## INSPECTION PERMIT

Permit Number: 060359

ONE AND TWO FAMILY		PLAN REVIEW		CHECKLIST	
Soil type/Presumptive Load Value (Table R401.4.1)		Submitted Plan		Findings	Revisions
Component		Submitted Plan		Findings	Date
<b>STRUCTURAL</b> Footing Dimensions/Depth (Table R403.1 & R403.1(1)), (Section R403.1 & R403.1.4.1)		OK - 4' frost			
Foundation Drainage, Fabric, Damp proofing (Section R405 & R406)		N/A			
Ventilation/Access (Section R408.1 & R408.3) Crawls Space ONLY		only in one area - large access doors - the 1/2" x 12" - 6' oc			
Anchor Bolts/Straps, spacing (Section R403.1.6)					
Lally Column Type (Section R407)		N/A			
Girder & Header Spans (Table R 502.5(2))					
Built-Up Wood Center Girder Dimension/Type		N/A			
Sill/Band Joist Type & Dimensions		2x6			
First Floor Joist Species Dimensions and Spacing (Table R502.3.1(1) & Table R502.3.1(2) )		9 1/2" BEI - 2" oc 16' span - OK			
Second Floor Joist Species Dimensions and Spacing (Table R502.3.1(1) & Table R502.3.1(2) )		14" TJJs / 9 1/2" BEI

RE: Smith Residence, Lot 21, River's Edge Drive

5
**PLAN AT FIREPLACE**  
A-3.2 SCALE: 3/4" = 1'-0"

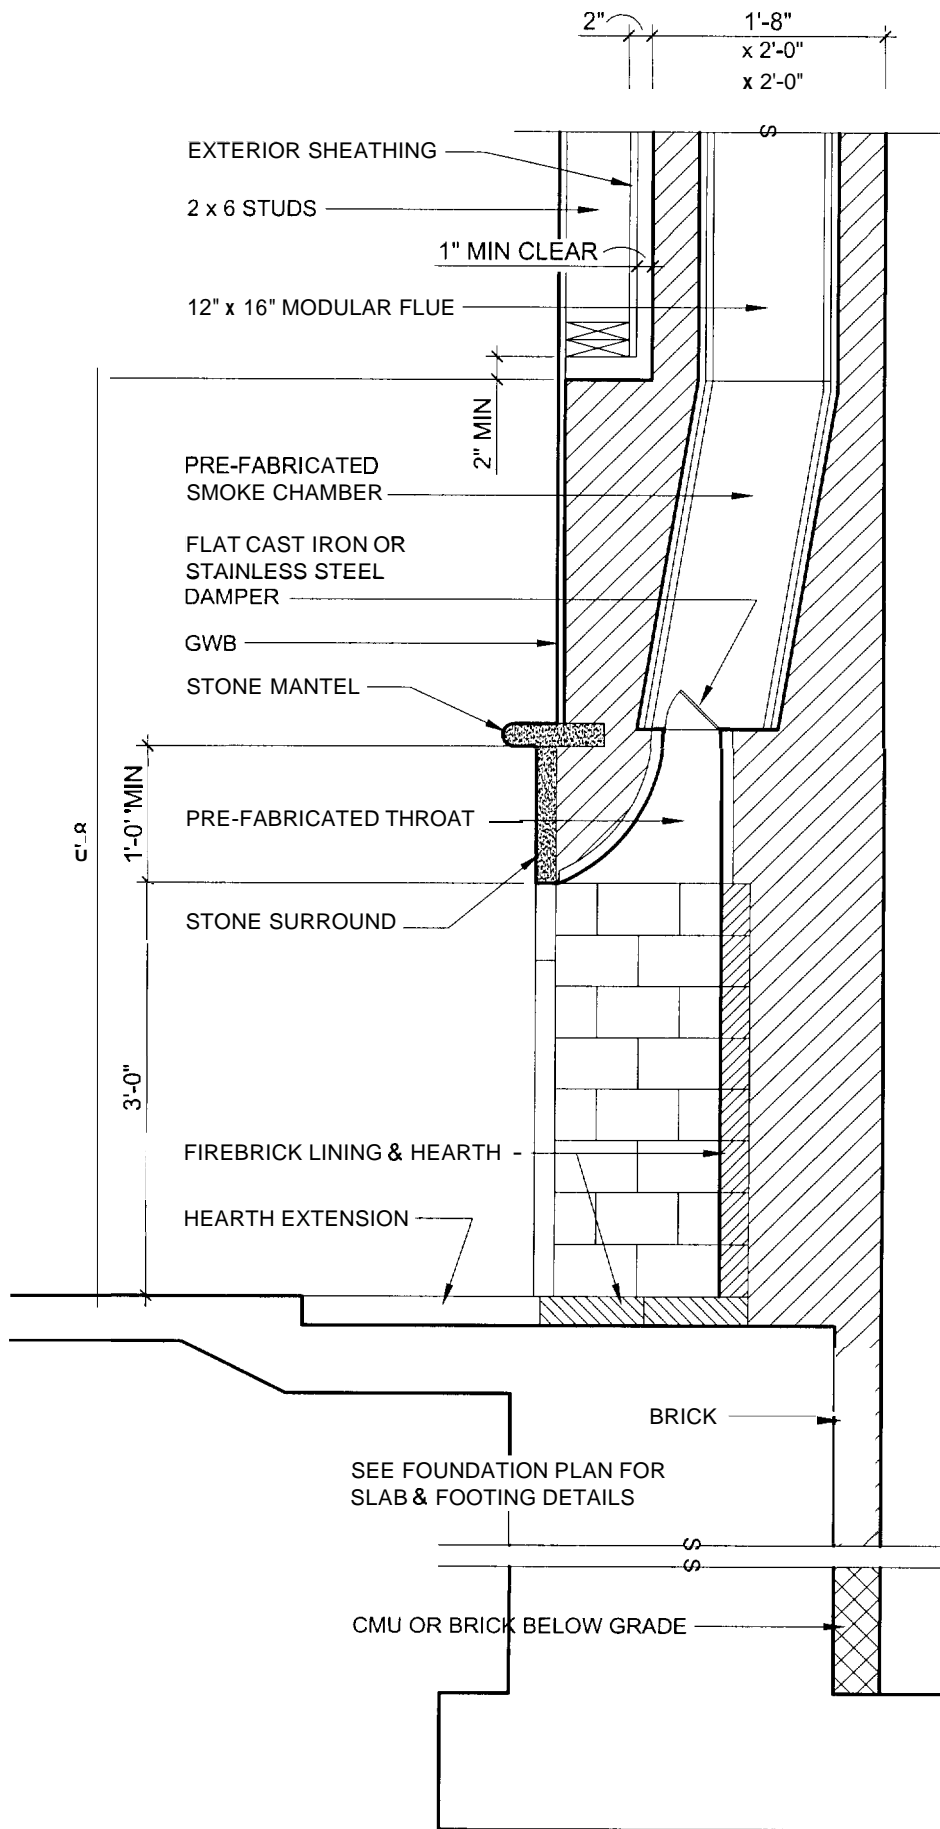
3.) Included here are drawings for the fireplace and chimney (see Pages 1 & 2).

5 SECTION AT BATH 2  
 A-3.1 SCALE: 1/4" = 1'-0"

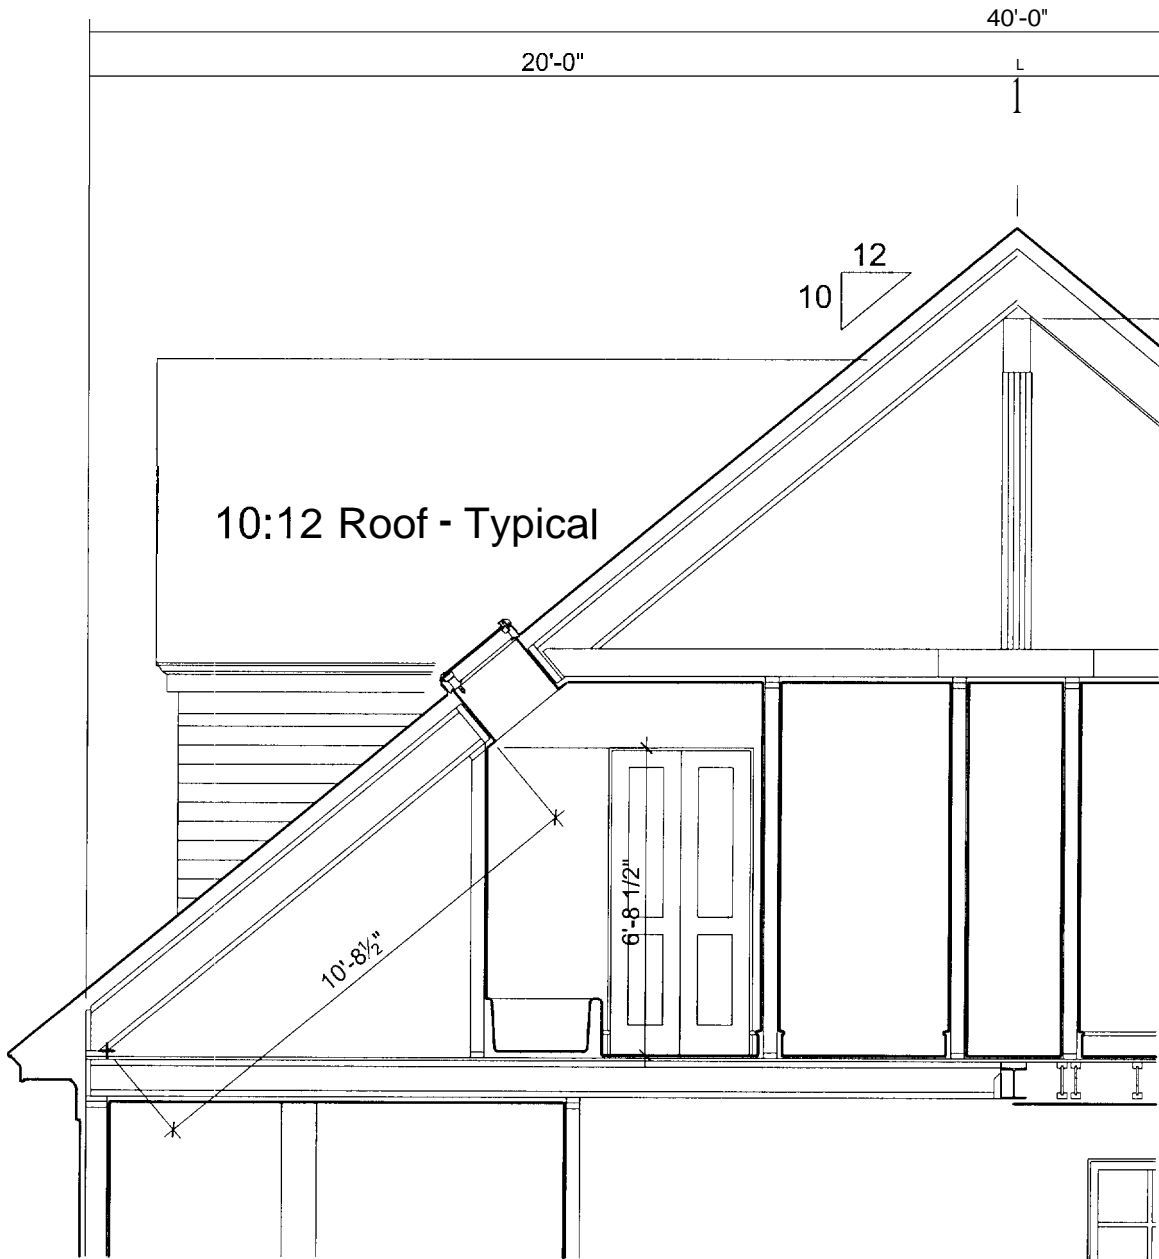
*Section showing headroom height in 2nd floor back*

7.) Included here is a section through the Second Floor Bathroom (see Page 3). We have adjusted the plan so that the minimum ceiling height above the tub and toilet is 6'-8".
